PAR Change for P802.3bt

Proposed change

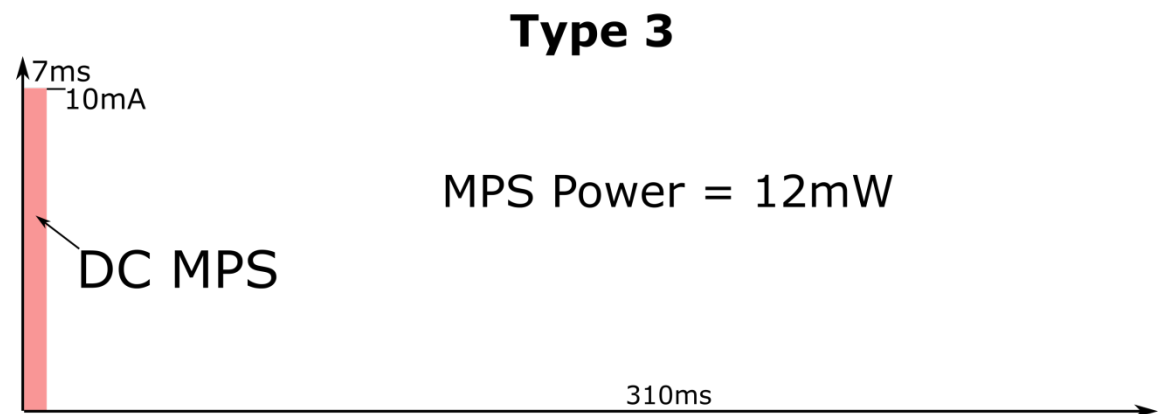
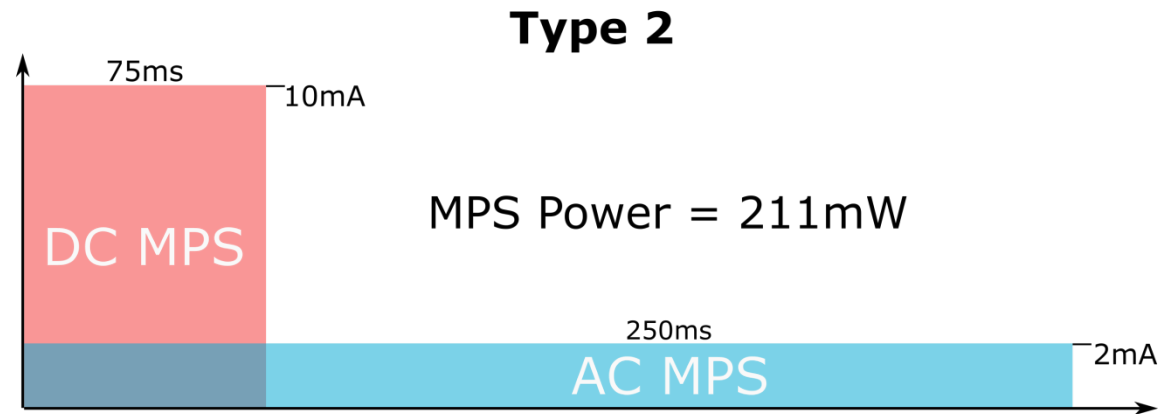
5.2.b. Scope of the project: The scope of this project is to augment the capabilities of the IEEE Std 802.3 standard with 4-pair power and associated power management information. The project will augment the methodology for the provision of power via balanced cabling to connected Data Terminal Equipment with 802.3 interfaces. Optional augmented power limit will be made available for certain structured cabling systems. Compatibility with existing equipment will be maintained.

5.2.b. Scope of the project: The scope of this project is to augment the capabilities of the IEEE Std 802.3 standard with 4-pair power and associated power management information. The project will augment the methodology for the provision of power via balanced cabling to connected Data Terminal Equipment with 802.3 interfaces. Optional augmented power limit will be made available for certain structured cabling systems. **Improvements introduced for 4-pair systems, excluding raising the power limit, may be enabled for 2-pair systems.** Compatibility with existing equipment will be maintained.

- 802.3bt is creating two new Types (PSE & PD)
 - **Type 3** allows **60W** PSE power
 - **Type 4** allows **90W** PSE power
- New features have been added to these new Types that also provide benefit for 2-pair systems at power levels addressed by Type 1 (802.3af) and Type 2 (802.3at)
- Type 3 PSEs are allowed to operate over 2P only with maximum power of 30W and provide these new features. This requires a PAR change.
